RE: MOUNT PLEASANT OPERATION (DA 92/97 MOD 3) – REQUEST FOR ADDITIONAL INFORMATION

In response to the Department's letter dated 22 December 2017 requesting additional information on MACH Energy Australia's (MACH Energy's) proposed Mine Optimisation Modification (Modification 3), we have responded in the same order raised in the Department's request.

Figure 1

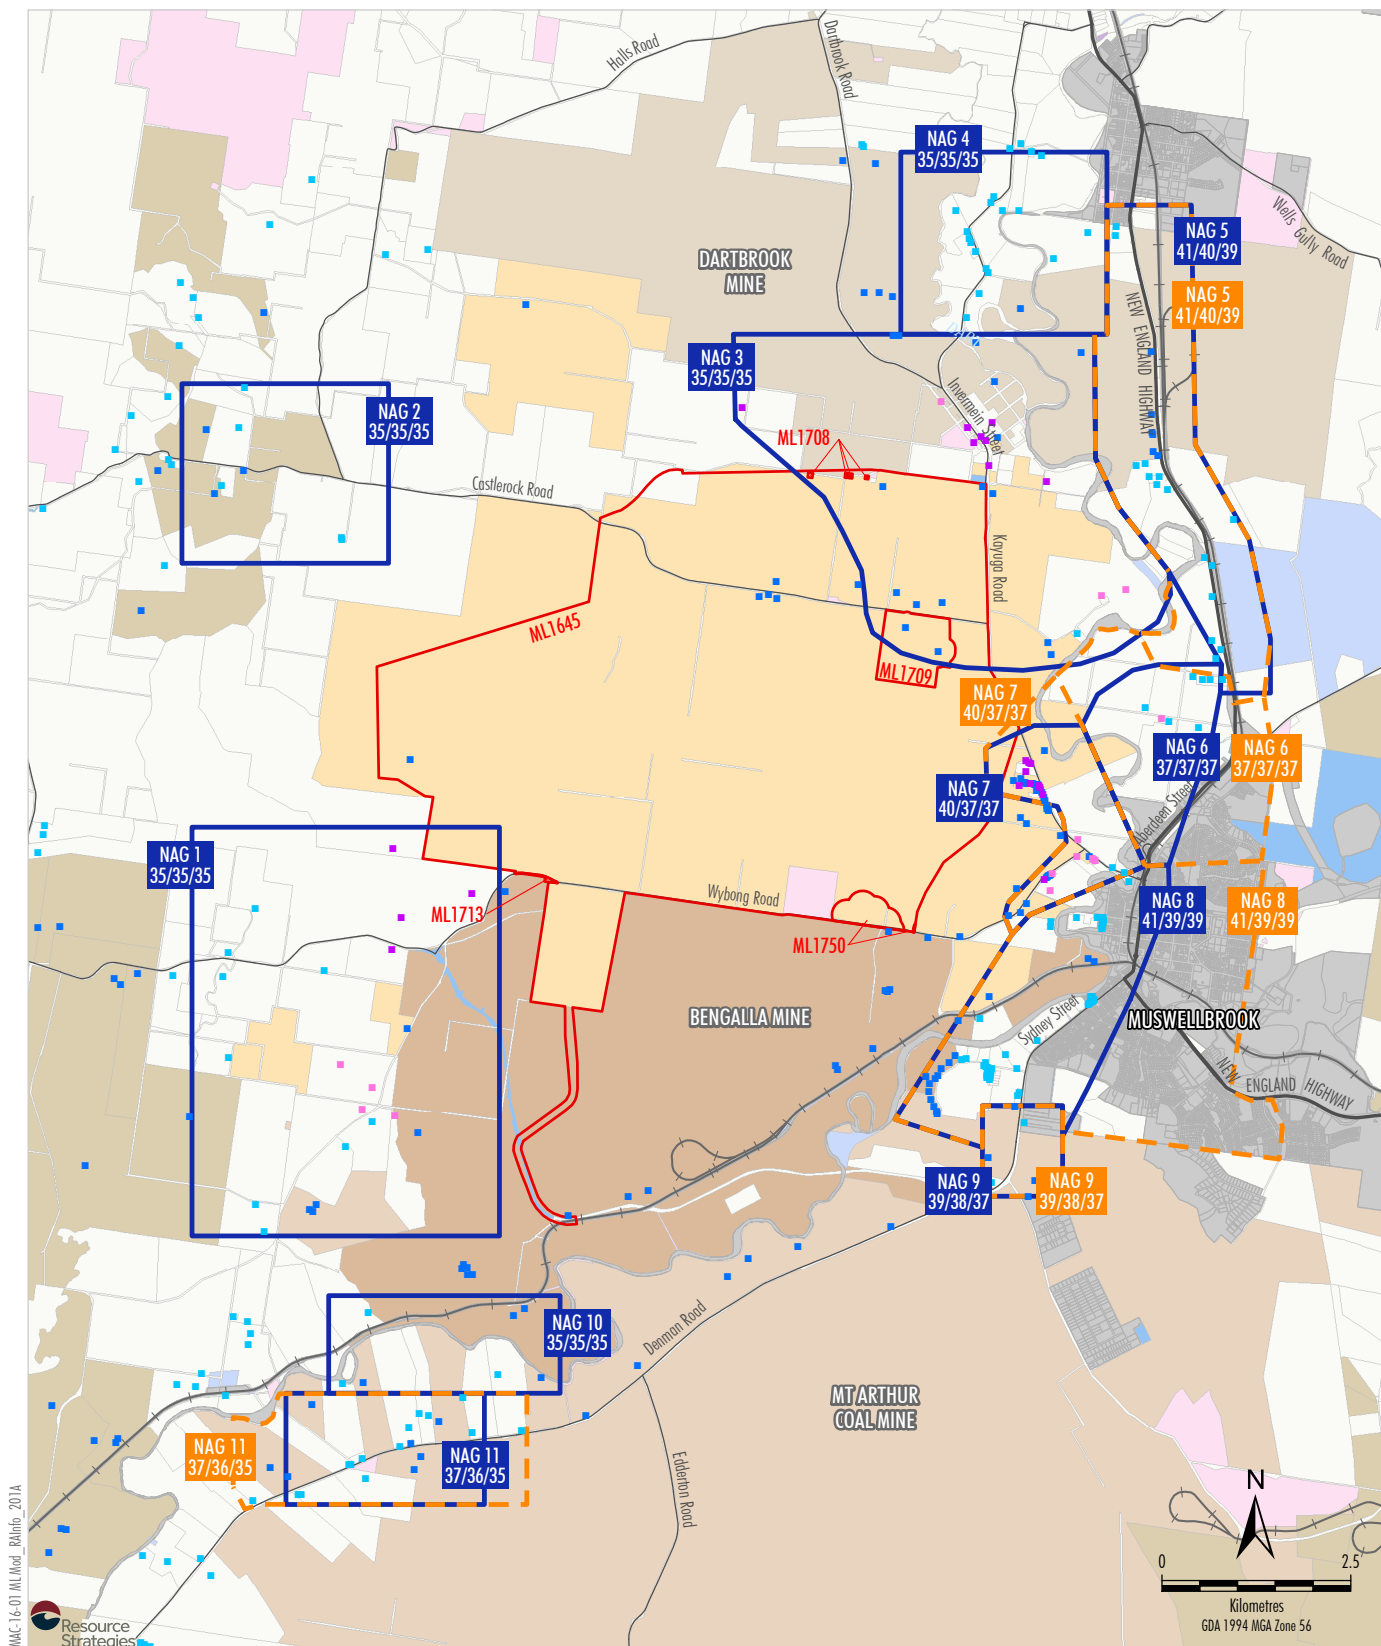
The Environmental Assessment (EA) identifies that the delineation of noise assessment groups (NAGs) has been amended relative to the existing approved project. The Department does not consider that sufficient justification has been provided for the proposed changes in NAGs, which would increase the existing noise criteria applicable to a substantial number of properties. Further, the Department is not yet convinced that all of the proposed extensions to existing NAG boundaries are reflective of background levels in these locations.

I also note that the proposed NAG boundaries appear to cover a broad range of predicted noise levels, for example NAG 8 includes predicted impacts ranging between 45 dB in the west to less than 35 dB in the east. Given this range of predicted impacts, the Department is unlikely to recommend the application of uniform noise criteria for all residents within these areas, especially in areas such as east Muswellbrook where the project is predicted to meet lower noise limits. I would therefore request that further consideration is given to the refinement and differentiation of receivers within NAGs (especially NAGs 6, 7 and 8).

In summary these were (Figure 1):

- A number of the NAGs were redundant (i.e. NAGs 1, 2, 3, 4 and 10).
- Minor adjustment to NAG 5 and 11 boundaries to include additional proximal residences identified by MACH Energy's new dwelling verification along major transport corridors.
- Adjust NAG 6 and 8 eastern boundaries to better reflect land use where the previous NAG had an arbitrary boundary bisecting the town of Muswellbrook.
- Some other minor changes to better reflect local property boundaries.

Figure 2

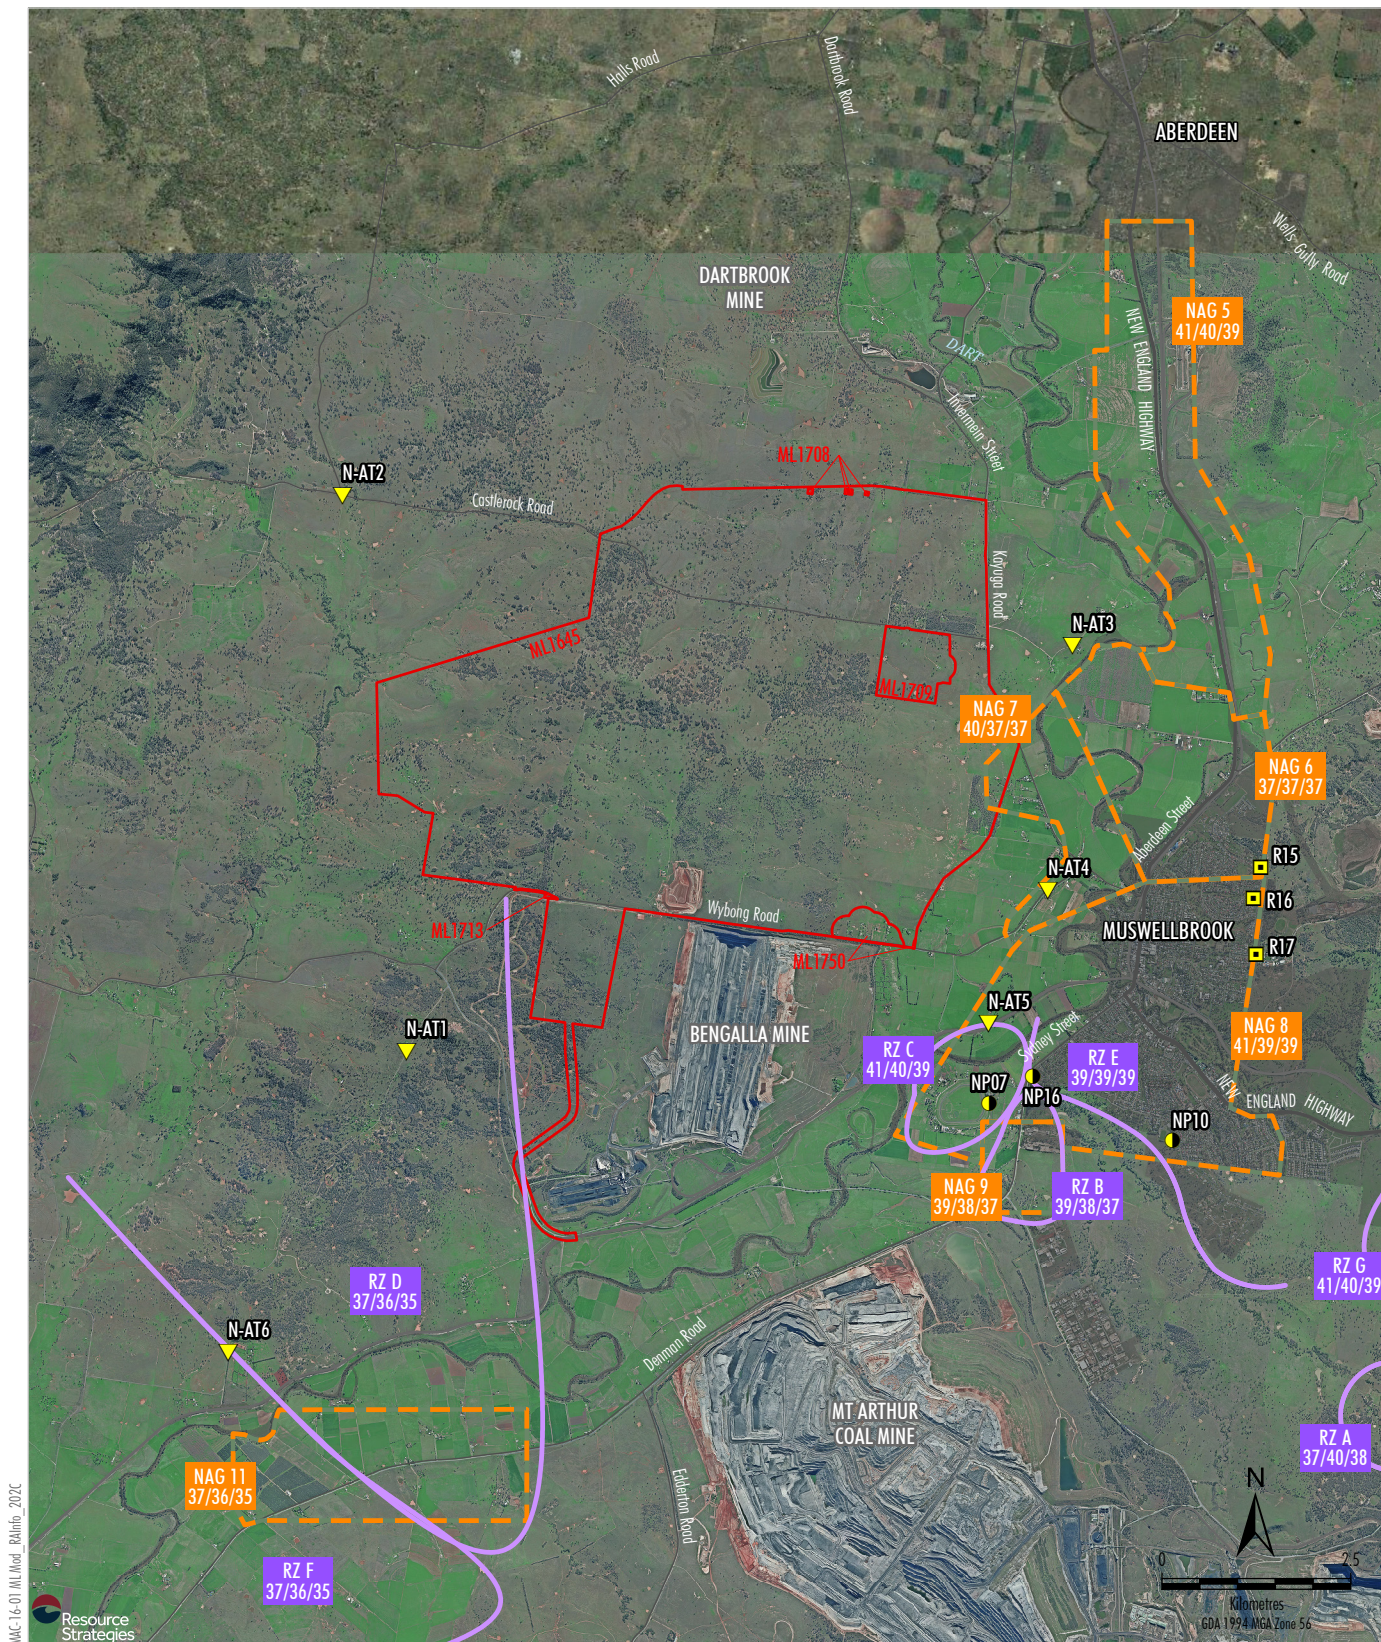
Review of current default noise impact assessment criteria for Mt Arthur (Project Approval 09-0062) Receiver Zones also generally indicates close correlation with the NAG boundary adjustments proposed in Modification 3 (Figure 2). However, residences to the south-east of NAGs 6 and 8 currently have a default noise impact criteria of 35/35/35 A-weighted decibels (dBA) (day/evening/night) for the Mount Pleasant Operation, whereas these same residences have default noise impact criteria of 39/39/39 dBA (day/evening/night) for Mt Arthur "Receiver Zone E" (Figure 2).

Contemporary compliance noise monitoring conducted by MACH Energy, Mt Arthur and Muswellbrook Coal also confirm that the background noise environment around the built up areas of Muswellbrook is typically materially higher than Industrial Noise Policy default background noise levels (Table 1 and Figure 2).

Figure 3

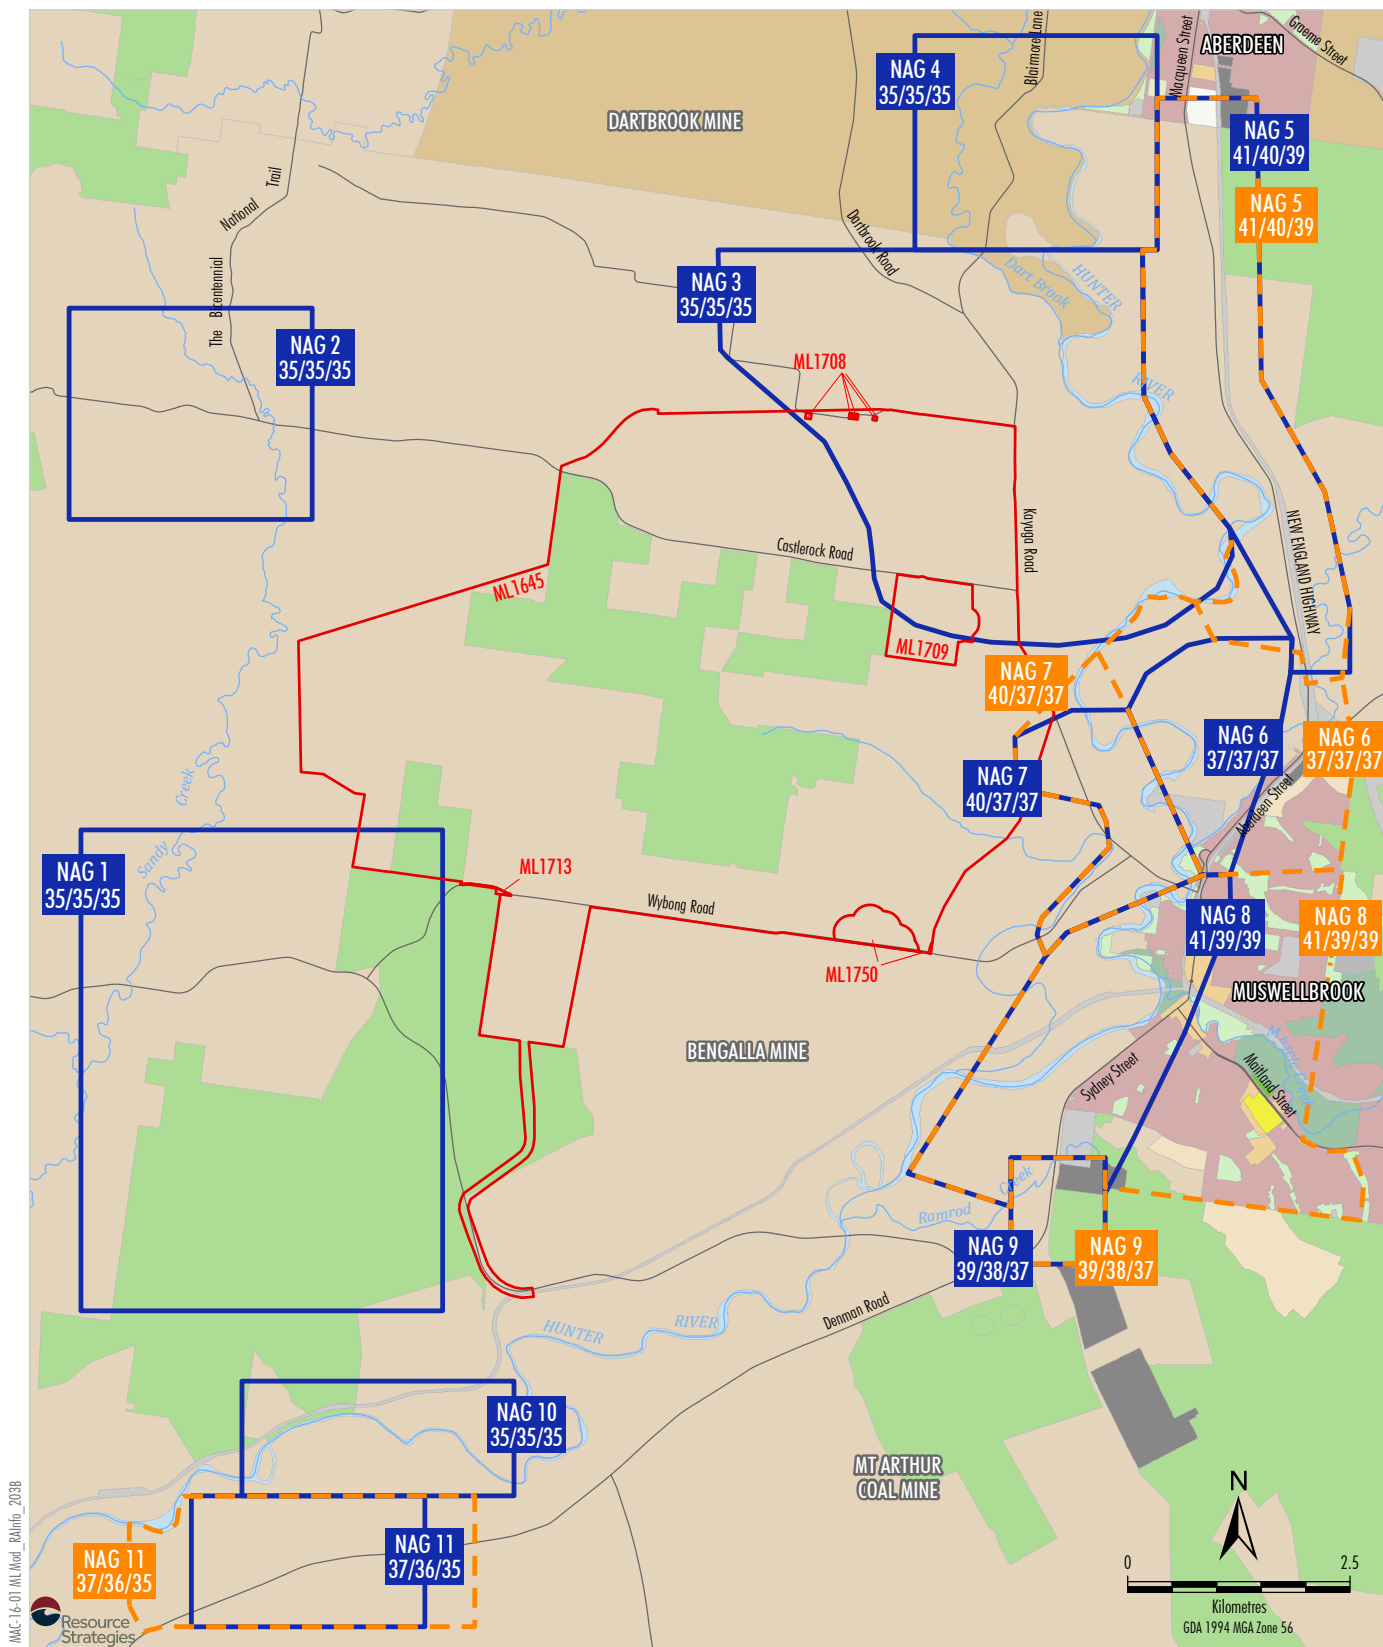
Review of the Muswellbrook Local Environmental Plan zonings also indicate Wilkinson Murray's proposed revised NAG 6 and NAG 8 eastern boundaries are generally reflective of the residential/developed area of Muswellbrook (Figure 3).
